Re: Florida Power & Light Company
Proposed Turkey Point Units 6 and 7
Docket Nos. 52-040 and 52-041
Response to NRC Request for Additional Information Letter No. 025 (eRAI 5414) -
Standard Review Plan Section 3.5.1.6 Aircraft Hazard

Attachment 1: FPL Response to NRC RAI No. 03.05.01.06-1 (RAI 5414)

NRC RAI Number: 03.05.01.06-1 (eRAI 5414)

Figure 1: Bearing Angle Graphical Method Verification

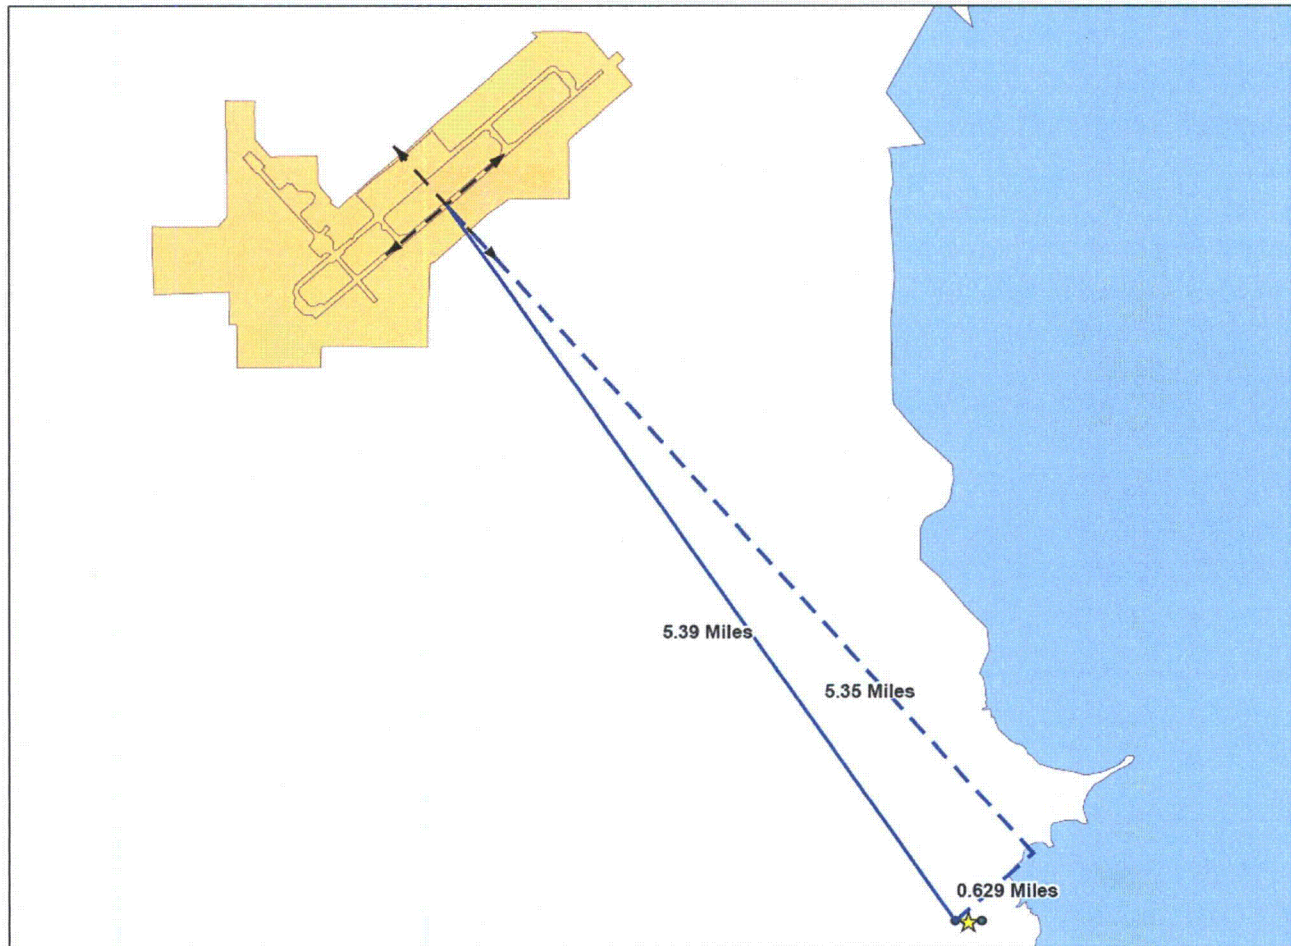
Subsection C: Provide the calculations with the details of aircraft crash rates, the assumptions for effective areas calculations, and the parameters for aircraft crash location conditional probability (per square mile) for each aircraft type and for each flight phase used in determining this total annual aircraft crash impact probability (F).

The bearing angle, Θ , for each runway and the distance, R, from the facility to the midpoint of each runway was determined using Geographic Information System (GIS) software. The bearing angle from the facility to the midpoint of the runway was determined by measuring the angle in degrees in a clockwise direction from true north at the reference point (facility) to the straight line joining the two points together. The x and y values determined from the bearing angles and equations (5) and (6) were verified using a second graphical method presented in the DOE Standard (DOE, 2006; pp. B-37 through B-38), as depicted in Figure 1. The graphical method consists of placing the origin in the center of the runway and then drawing a line splitting the runway in half lengthwise—this represents the x-axis. Next, a line is drawn from the facility perpendicular to and intersecting the x-axis. The x and y values for Runways 05 and 23 are calculated below in Tables 3 and 4, respectively.
